Core Bus Corridor 15: Blackrock to Merrion - Preliminary Submission

Extract of the Sandymount to Blackrock Public Consultation, October 2016, showing 2.25m one-way cycle tracks

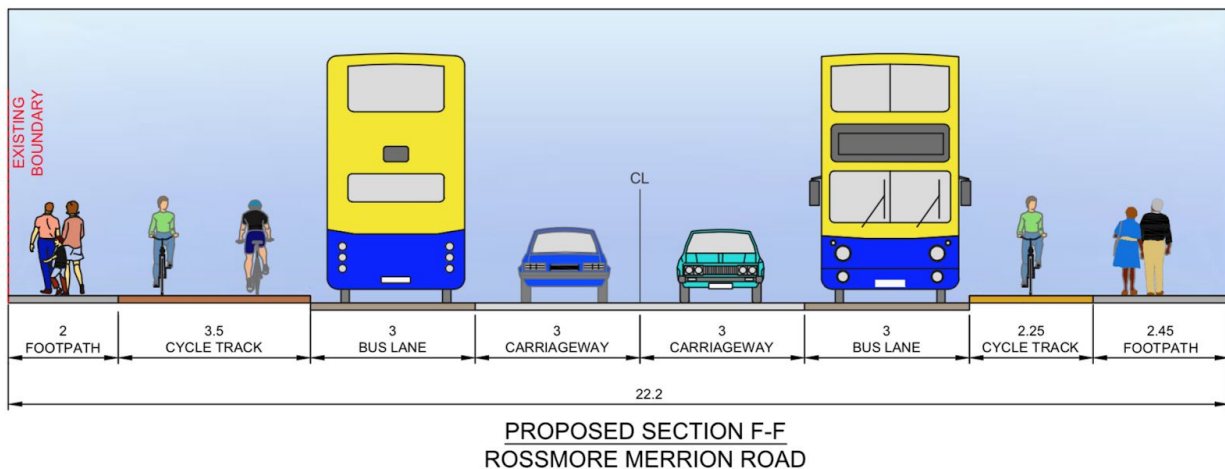
These proposals are an altered version of the Sandymount to Blackrock Cycle Scheme that the NTA put out to public consultation in October 2016. Those proposals included higher-quality cycle proposals than this Core Bus Corridor. The cycle tracks in that scheme were 2.25m wide where possible in many locations. Given that this is Primary Route 13A of the GDA Cycle Network Plan the cycle track should aim to be more than 2m, where possible.

Extract of the Sandymount to Blackrock Public Consultation, October 2016, with continuous dedicated cycle facilities

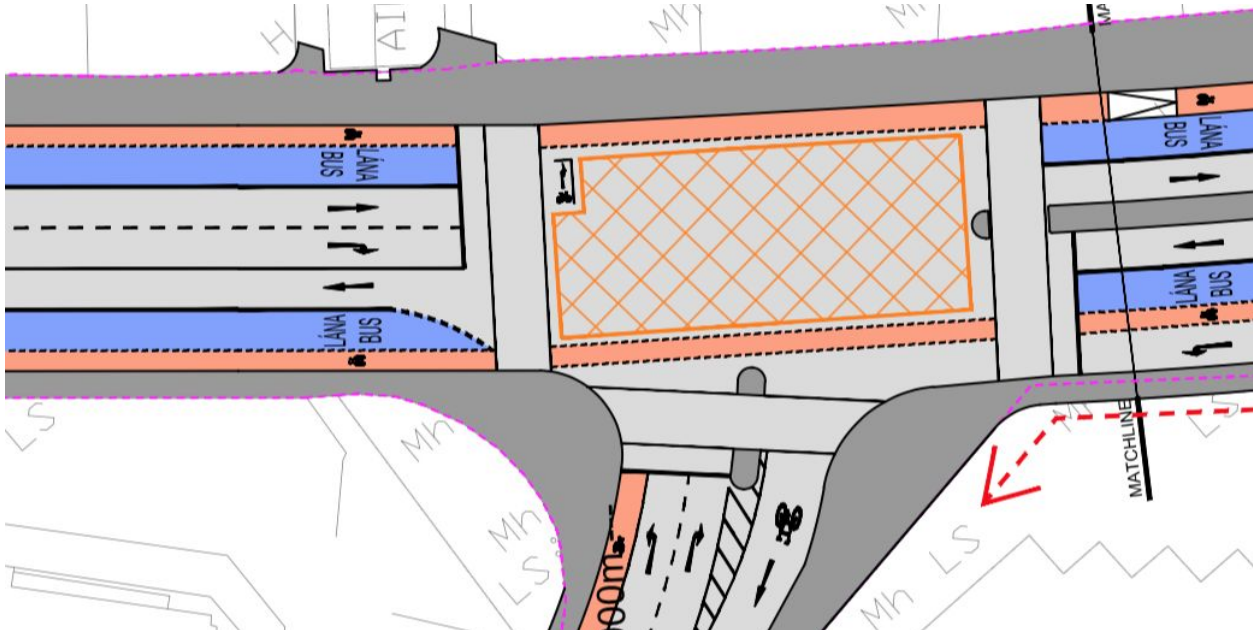
Although the Nutley Lane Junction is just outside this CBC on CBC14: UCD we will comment on it here too. The previous public consultation and the feasibility designs from AECOM include continuous dedicated cycle lanes through the junction.

Extract of CBC14: UCD public consultation document showing loss of the outbound dedicated cycle facility in order to make space for a bus priority light

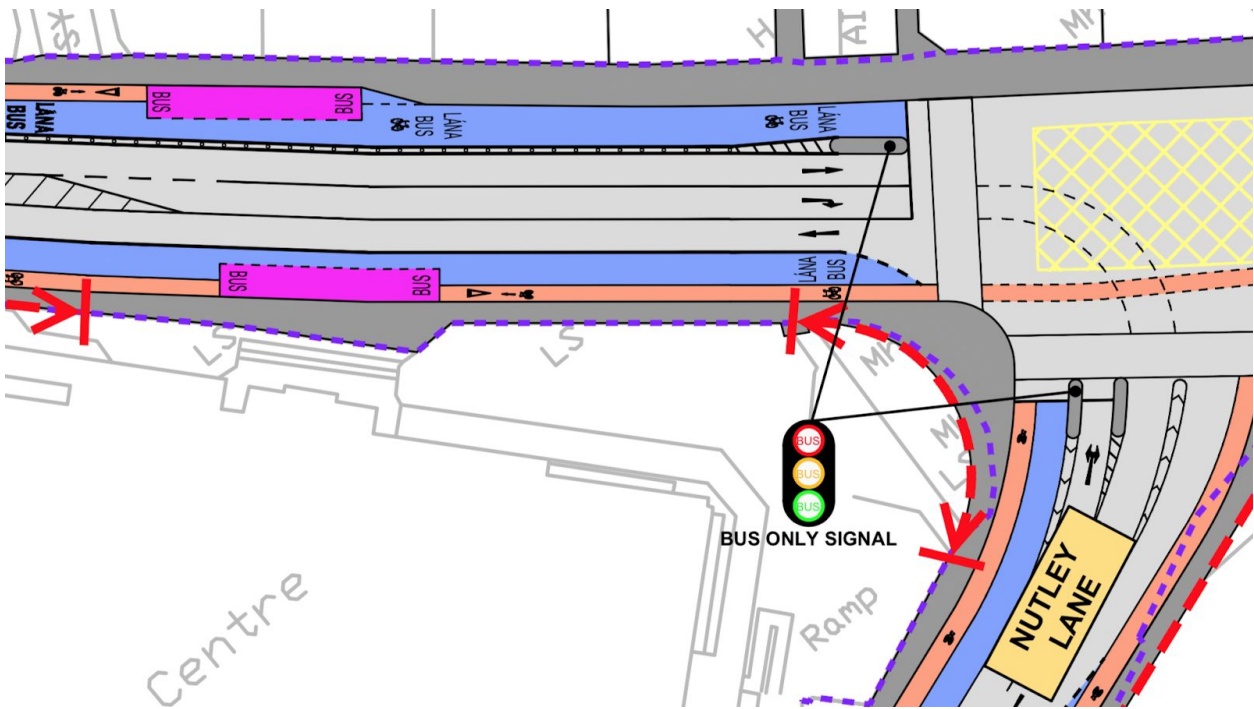
These dedicated cycle facilities have been compromised for a traffic island for bus priority lights. We understand the need for bus priority lights for right turning buses however, it must not come at the cost of dedicated cycle facilities at this location.
